Grange Engineering LLC

George Thebargue
Deer Creek Crossing
Final Approval Application- Comment Response

December 7, 2022

Town of Durham Planning Board,

DRAWN: CB	DATE: OCTOBER 19, 2022
DESIGNED: CB	SCALE:
CHECKED: CB	JOB NO. 1
FILE NAME:	
SHEET: C-303

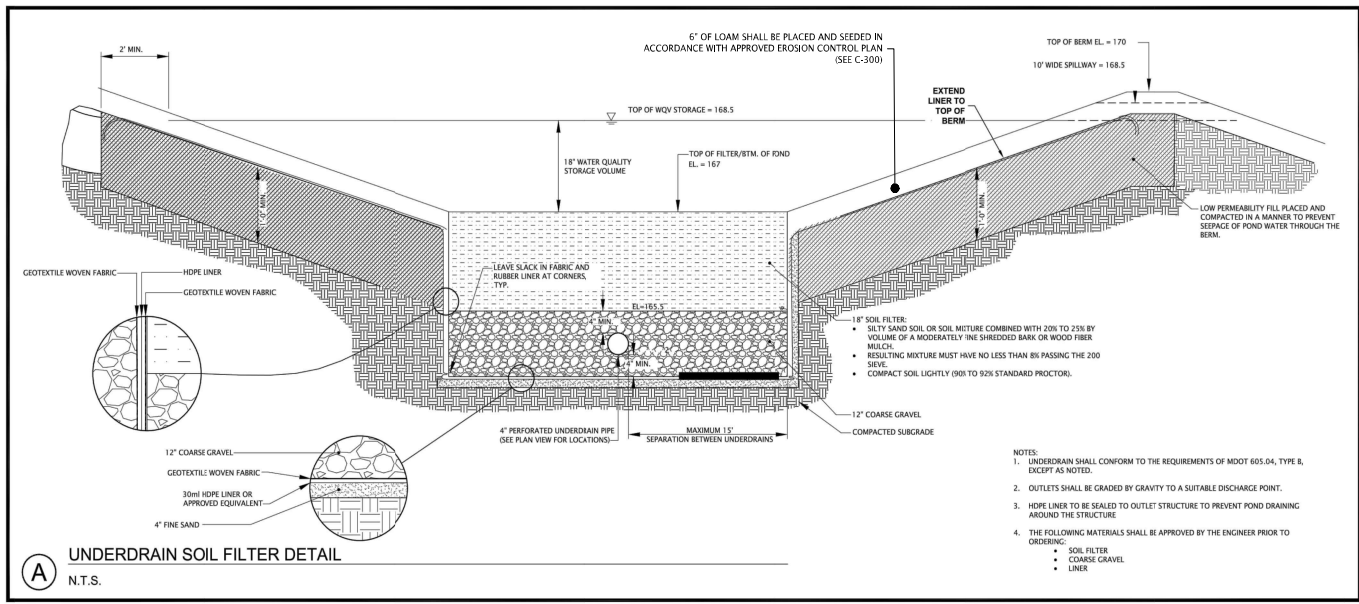
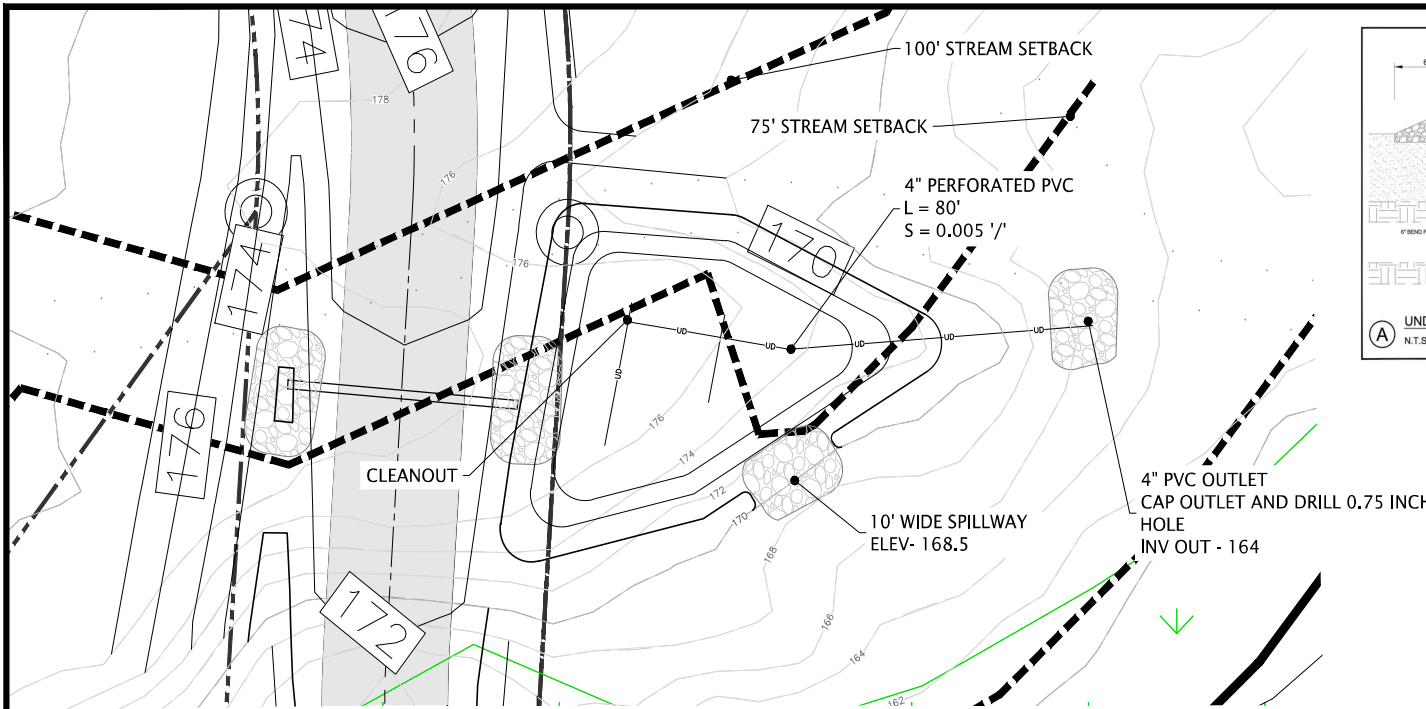
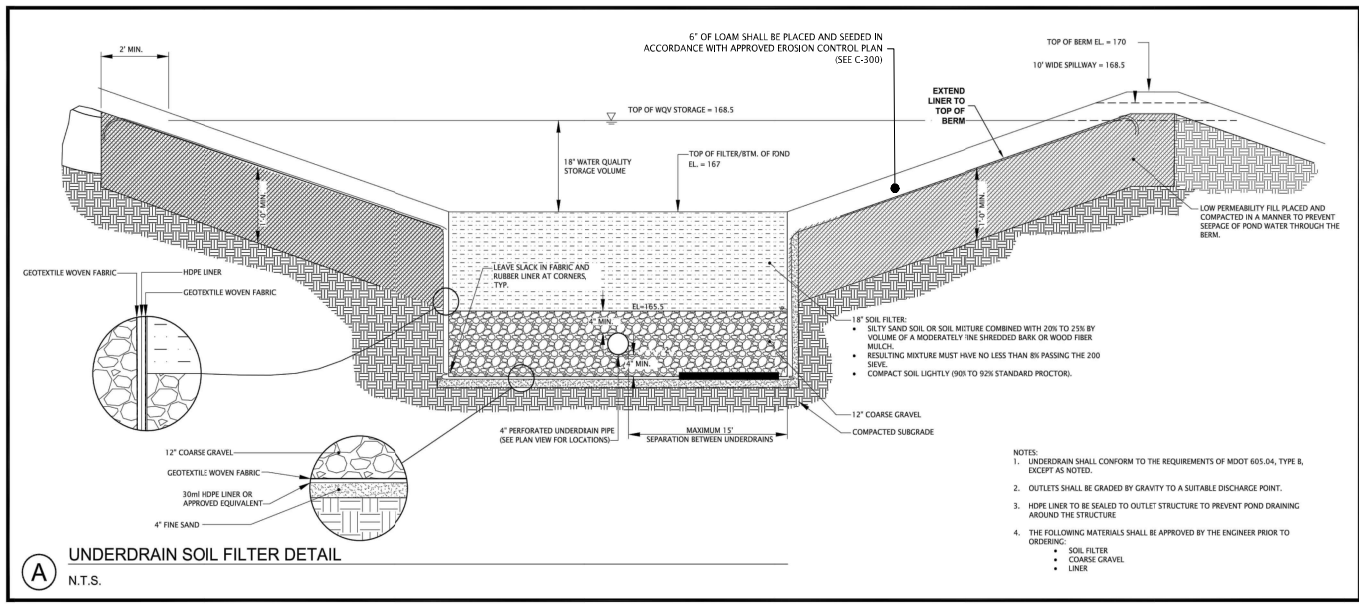
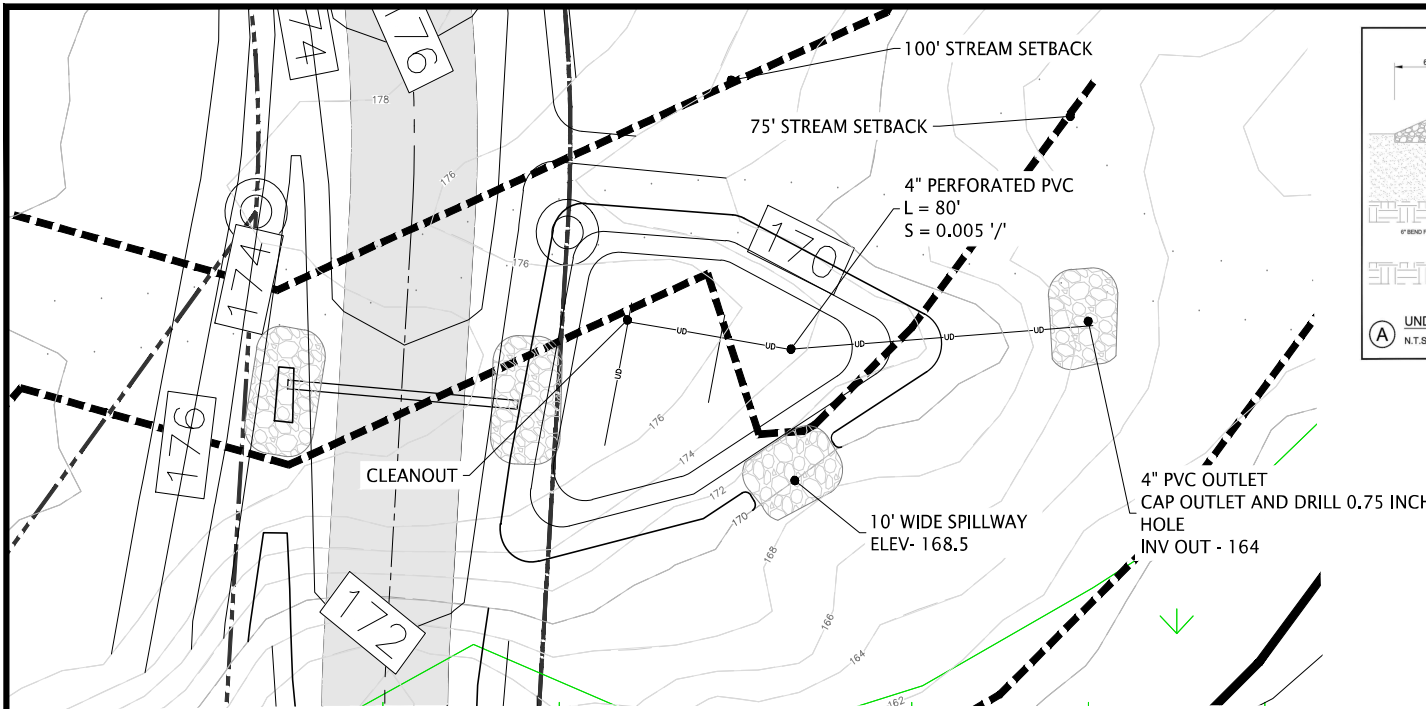
5. Provide a rip rap spillway detail for the ponds.

11. Show the stream setbacks on plan sheet C303.

13. The loam and seed on the sloped banks of the underdrained soil filter shall be called out on Detail Sheet C303. A reference to the seeding plan in the erosion control notes should be added to the underdrained soil filter detail for seeding of the soil media.

A note has been added specifying the spillway details on C-303.

Stream setbacks have been added to C-303.

C-303 has been updated.

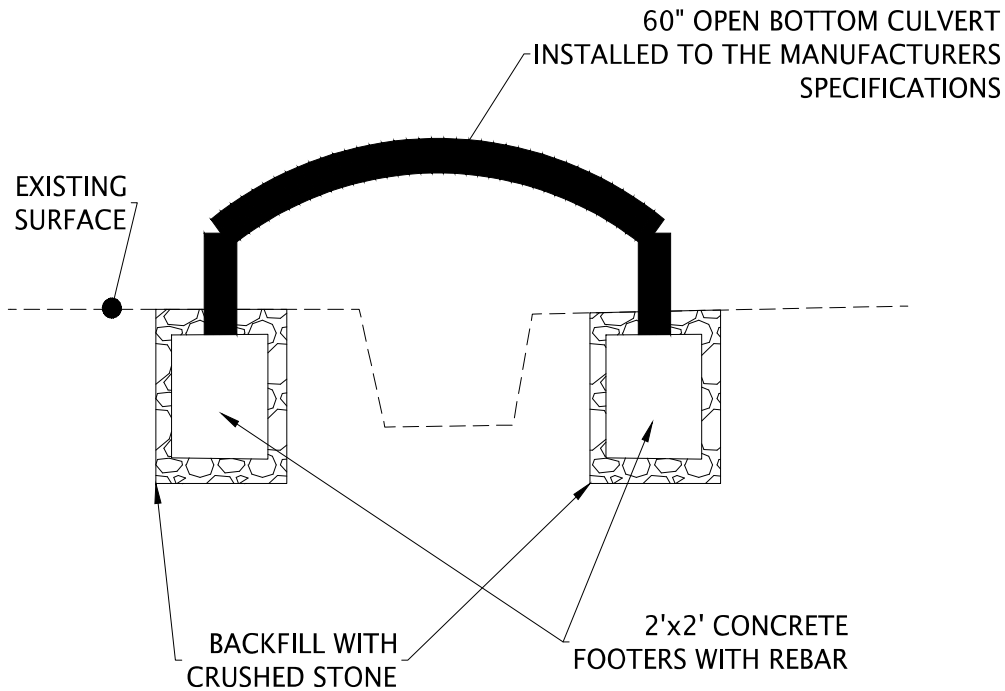
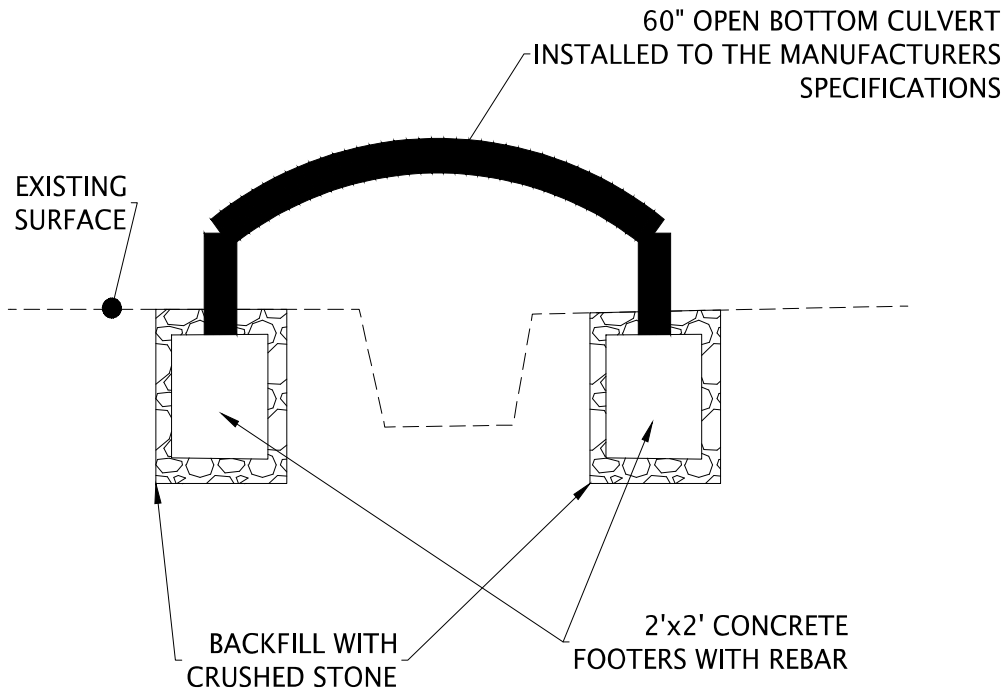
2. Sheet C-305 shows the stream crossing. We recommend that the detail be improved to show the size of the culvert footers and the top and bottom elevations of the footers. It is not clear if the cross section on this sheet is drawn to scale, (no scale provided). It is not clear what the effective cross-section of the new culvert will be as it appears that the top of the arch is set just about at the top of the existing stream banks, which may not be the intent. The culvert that is drawn in the section appears to be a metal "box" culvert shape rather than an "arch" shape. We have concerns that if more detail is not provided, it will be confusing at the time of construction on how to construct this culvert. The notes on this sheet could be confusing because they appear to be generic notes from the USACE General Permit. For example, notes 2.a, 2.b, and 5.2 do not apply to the arch-type culvert that is being installed for this project.

The details have been updated. The culvert could be boxed or arched as long as it spans 60".

DRAWN: CB DATE: OCTOBER 19, 2022
DESIGNED: CB SCALE: 1" = 100'
CHECKED: CB JOB NO. 1
FILE NAME:
SHEET: C-101

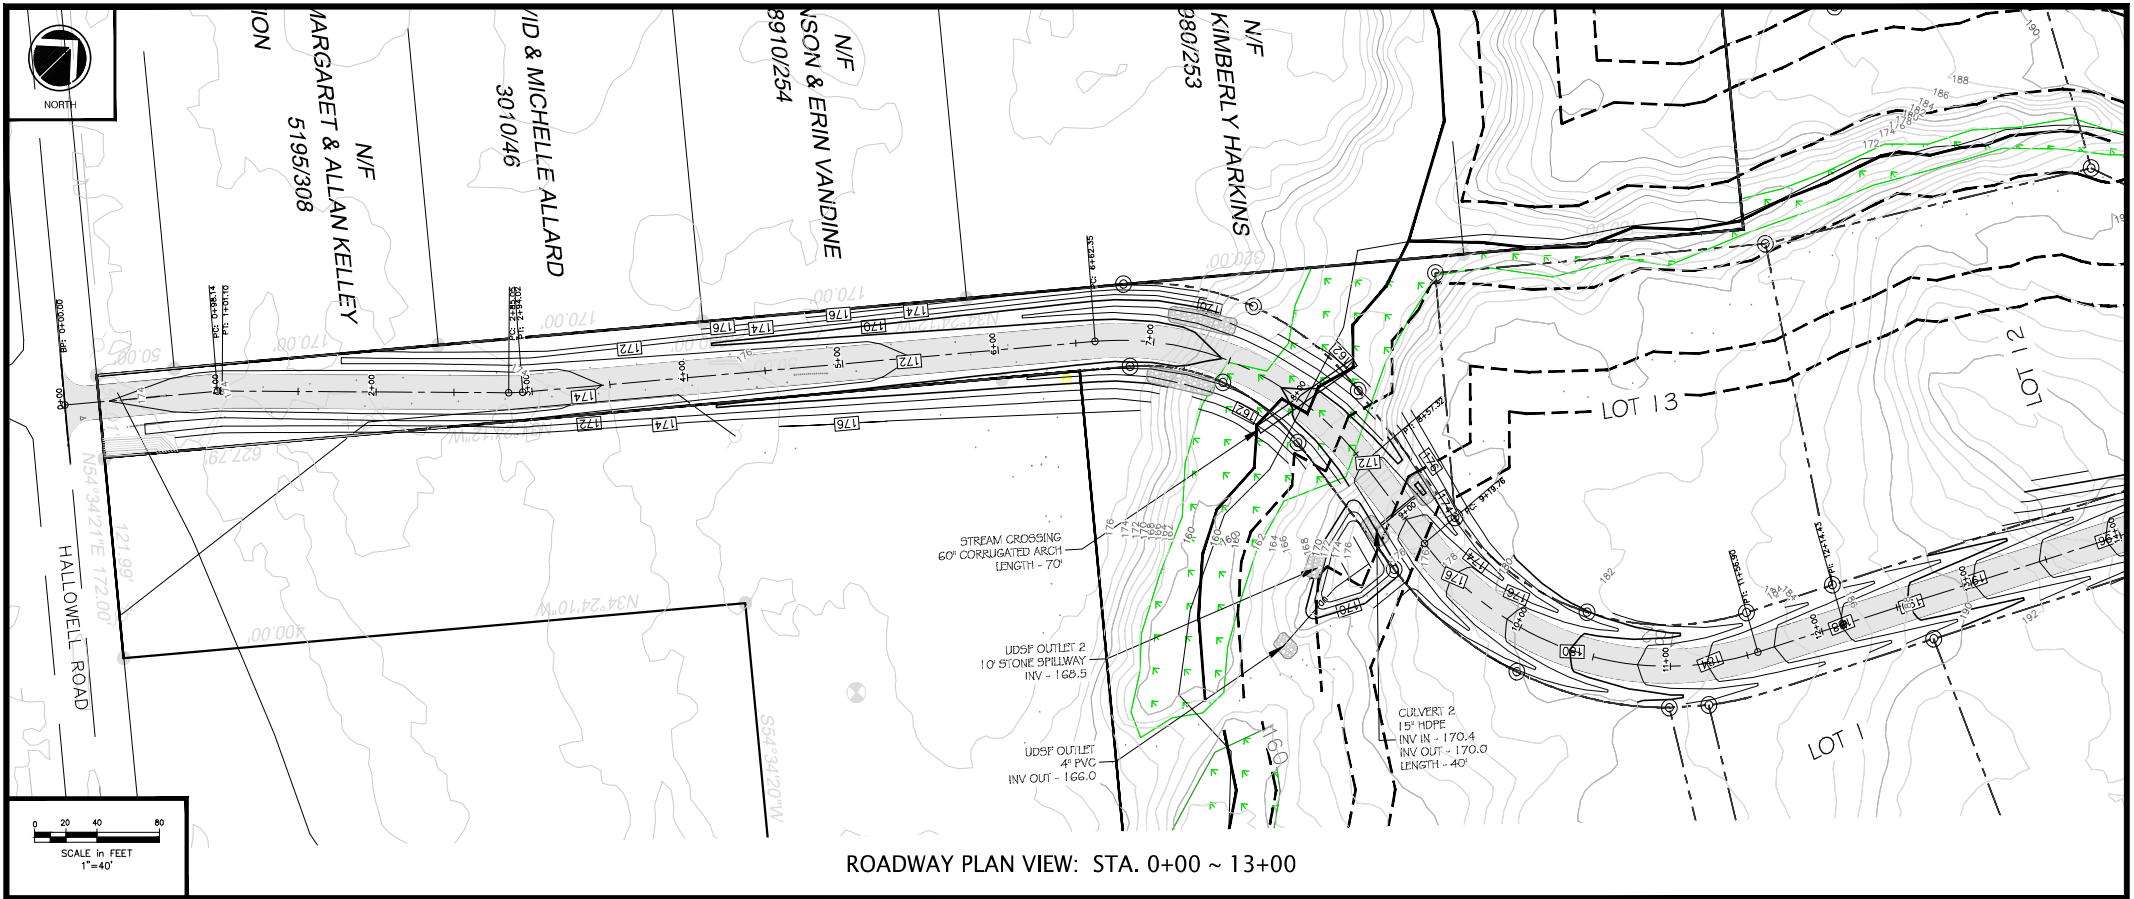
4. The response to prior comment #31 states that General Note 4 on Sheet C-101 has been removed. General Note 4 still indicates that if side setbacks are cleared during the grading of the lots or road, the same number of trees that were removed will be replanted. Our question remains. How will the number of trees that are removed during construction be quantified so the correct number can be replanted. It would be more appropriate to restrict tree cutting in the side setbacks.

Note #4 has been removed this time.

Grange Engineering LLC 241 Rowe Station Road New Gloucester, ME 04260 Tel: 207.712.6990	
DRAWN: CB	DATE: OCTOBER 19, 2022
DESIGNED: CB	SCALE:
CHECKED: CB	JOB NO. 1
FILE NAME:	
SHEET: C-200

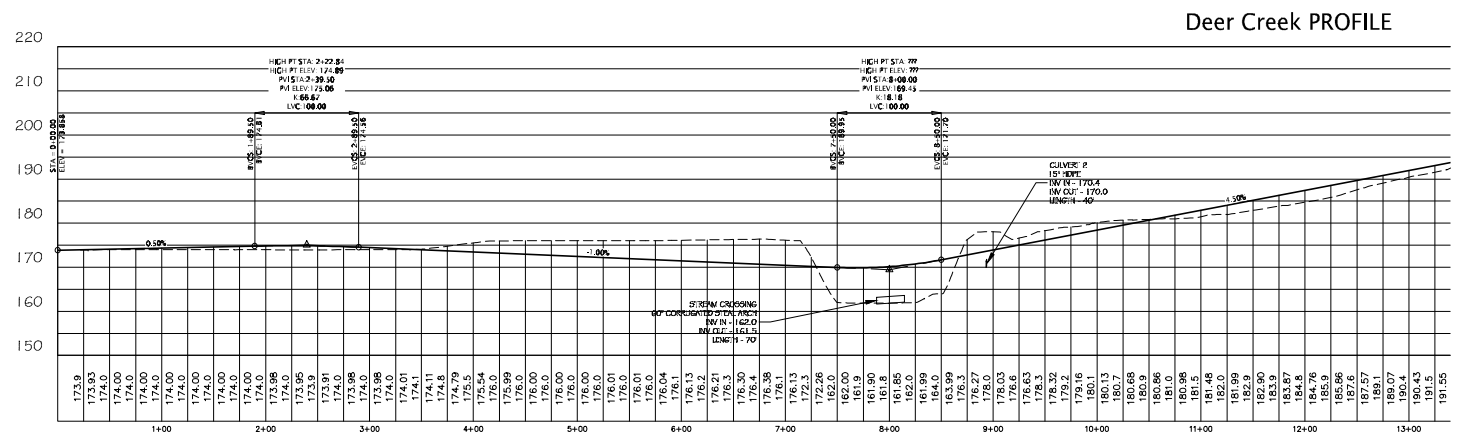
1. The plan view on sheet C-200 has the stream crossing culvert called out as 48", revise the size.

3. Sheet C-200 calls out invert-in and invert-out elevations for the culvert, however, since the structure is an open bottom arch, the inverts will be the natural inverts of the stream channel.

Note changed to say the 60" arch.

Inverts have been removed.
